## Iowa Department of Natural Resources (IDNR)

## Addendum

**In Reference to RFP for:** Water & Wastewater Connection to the City of Hampton **RFP No. :** 23CRDLWBPPAYT-0013

## **Answers to Questions from Potential Service Providers**

ATTACHMENT

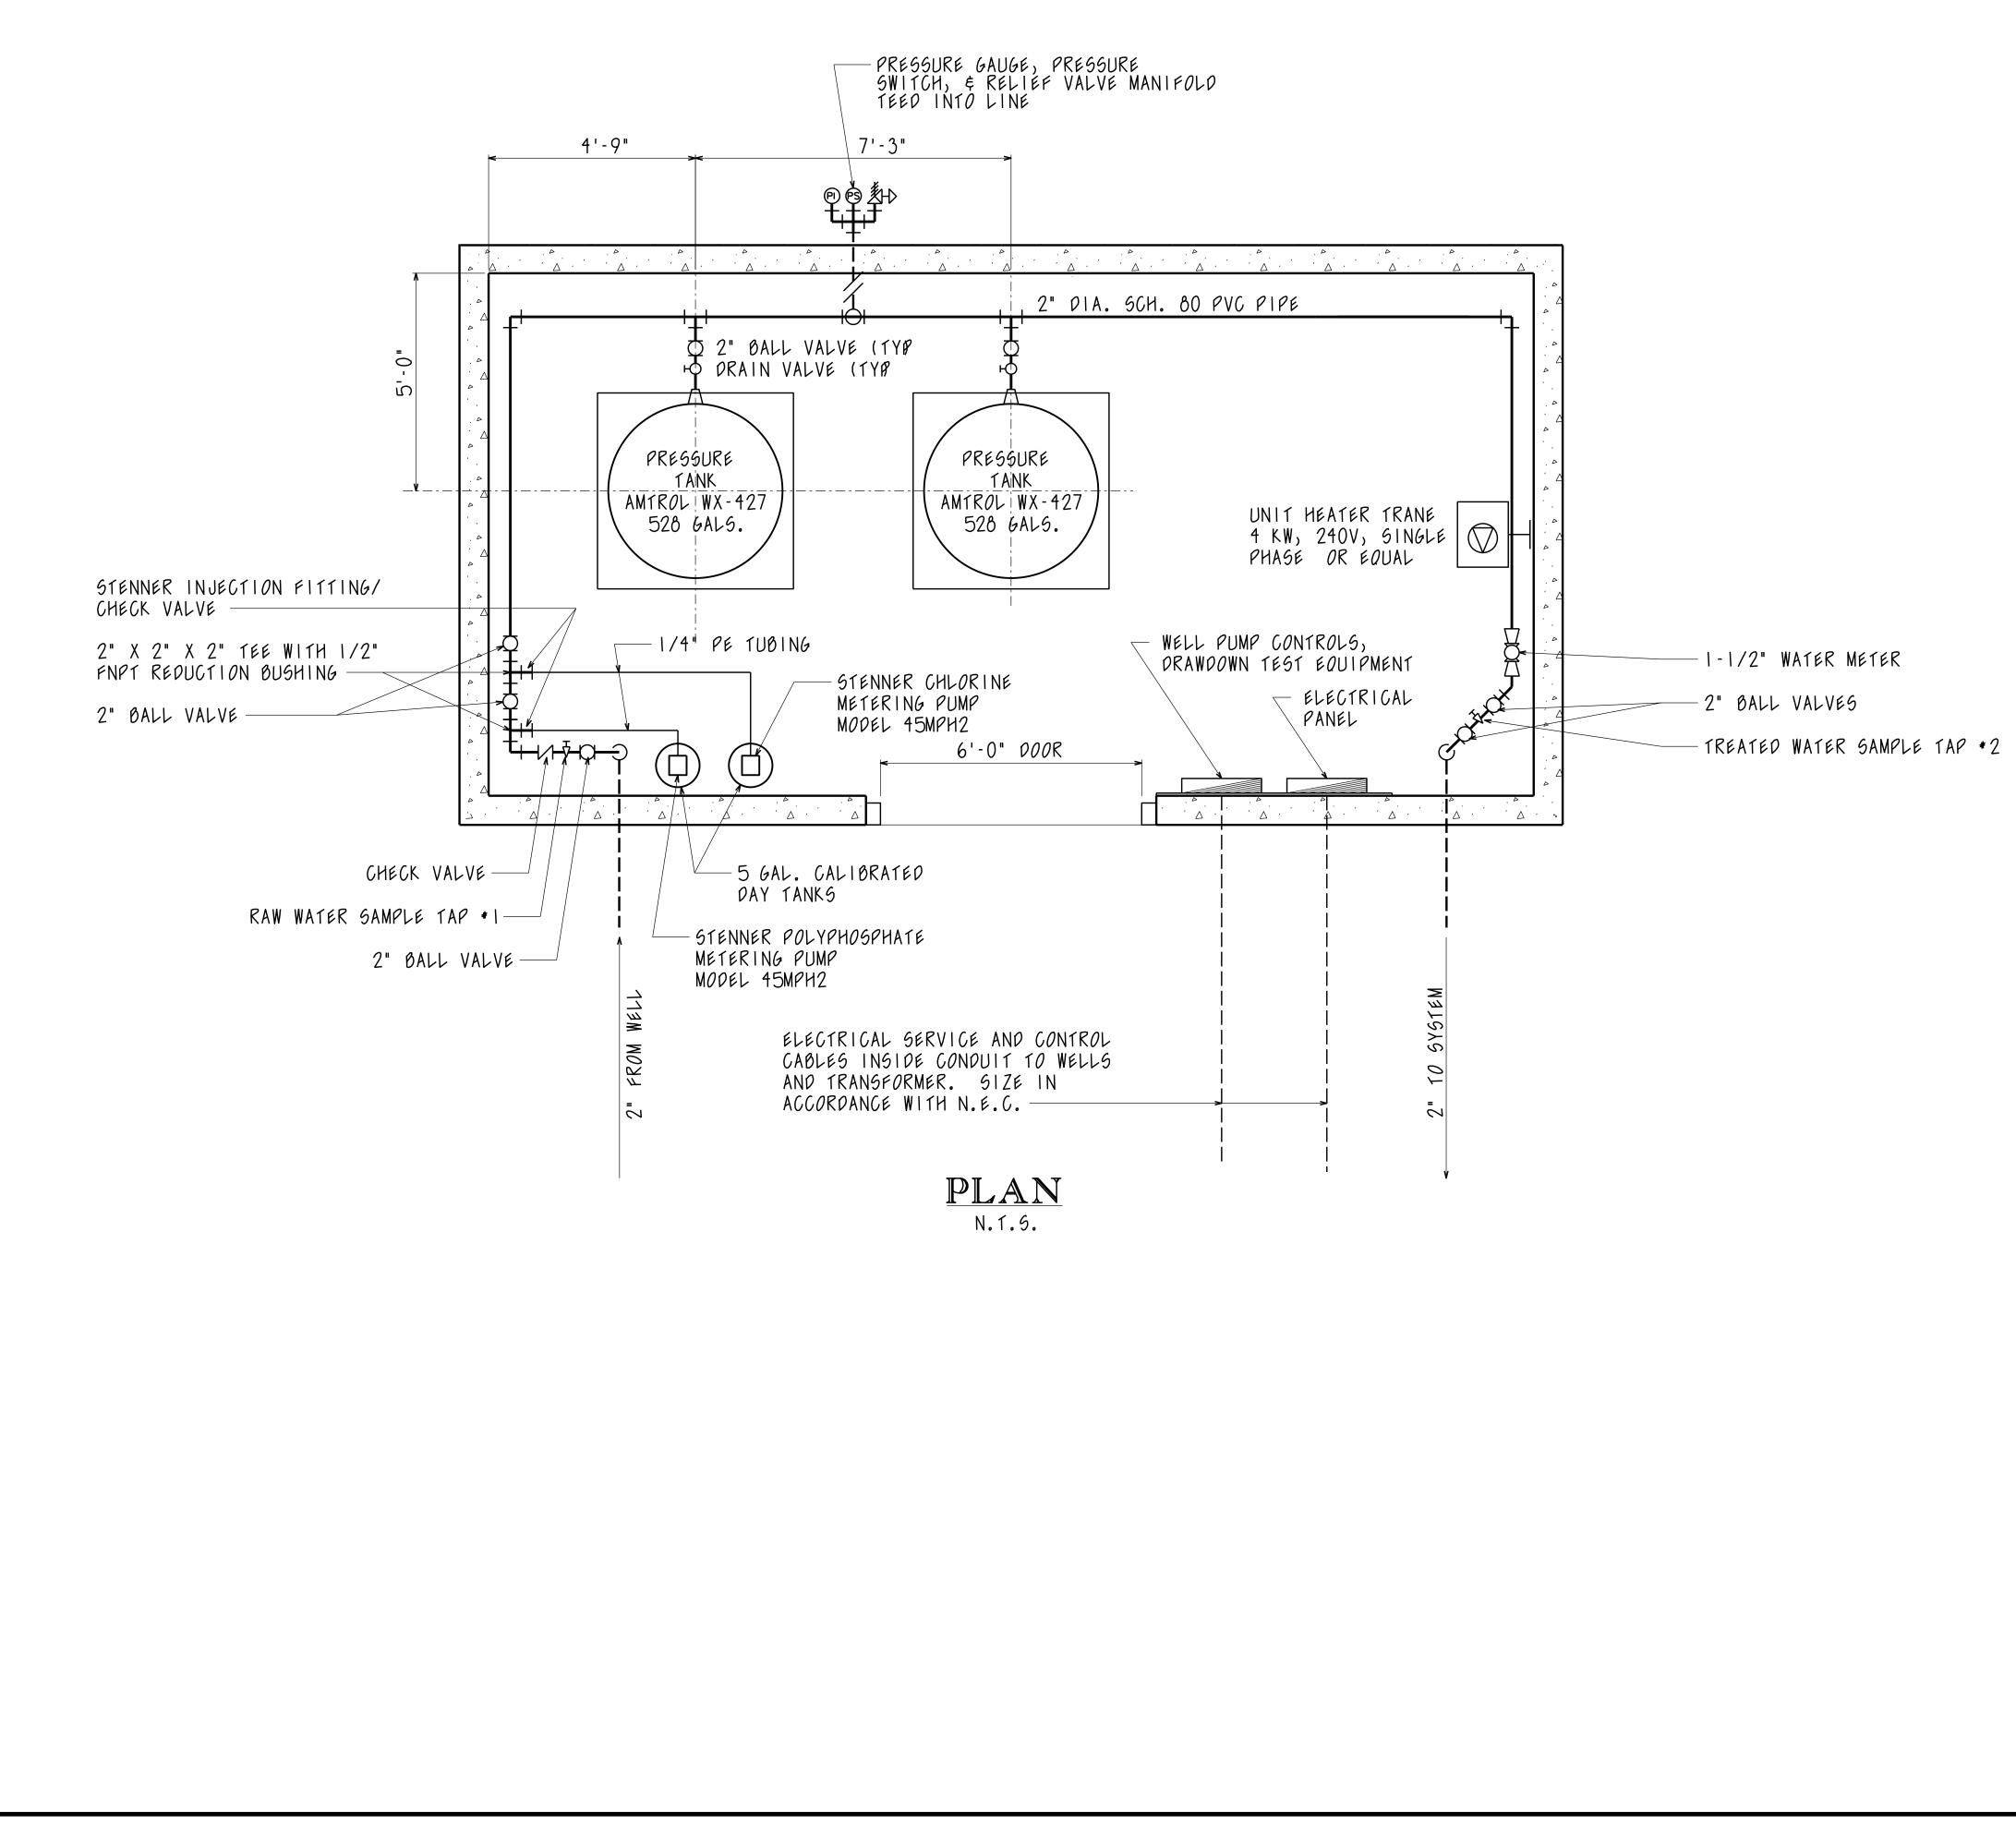
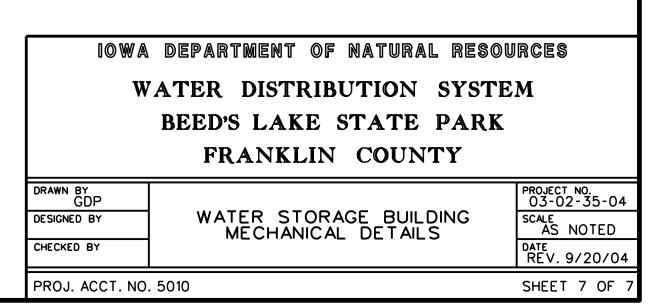
**10.** Page 15 Section 4.1 mentions that there is an existing disinfection building that could potentially be used for chemical addition and booster pumps. Please provide any and all information including drawings and photos of this existing building.

Most likely we will have enough residual chlorine and pressure once we receive the water from the city, but if we don't we would like to use our existing building for additional chlorine and pressure boost if needed. Attached to this addendum is the design of the building.
